**TSG-RAN Meeting #10
Bangkok, Thailand, 6 - 8 December 2000**

TSGRP#10(00)0625

Title: Agreed CRs to TS 25.427

Source: TSG-RAN WG3

Figure 20: Structure of the payload for Rx timing deviation control frame

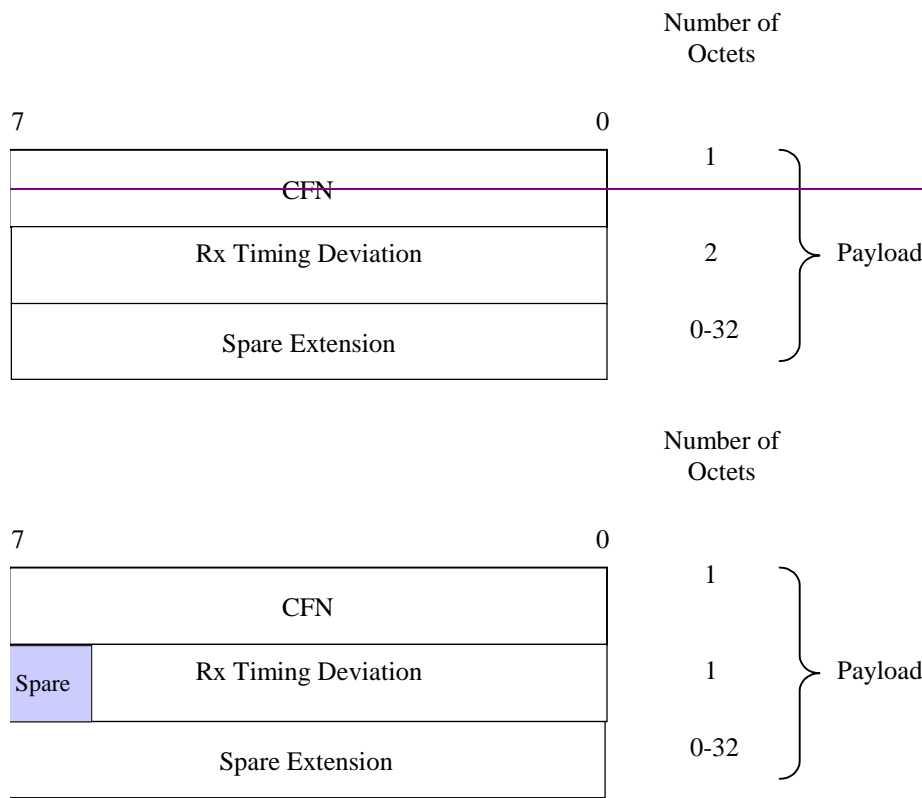
6.3.3.7 Rx Timing Deviation

Figure below shows the structure of the payload when the control frame is used for the Rx timing deviation.

Figure 7: Rx timing deviation

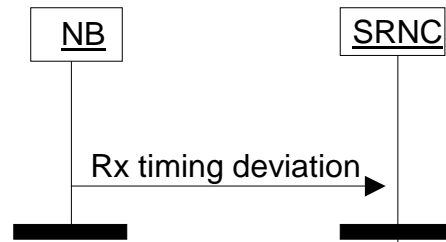
In case the *Timing Advance Applied* IE indicates “Yes” (see Ref. [4]) in a cell, ~~The~~ the Node B shall, for all UEs using DCHs, monitor the receive timing of the uplink DPCH bursts arriving over the radio interface, and shall calculate the Rx Timing Deviation. If the calculated value, after rounding, is not zero, it shall be reported to the SRNC in a RX TIMING DEVIATION Control Frame belonging to that UE. For limitation of the frequency of this reporting, the Node B shall not send more than one RX TIMING DEVIATION Control Frame per UE within one radio frame.

If the *Timing Advance Applied* IE indicates “No” (see Ref. [4]) in a cell, monitoring of the receive timing of the uplink DPCH bursts is not necessary and no RX TIMING DEVIATION Control Frame shall be sent.
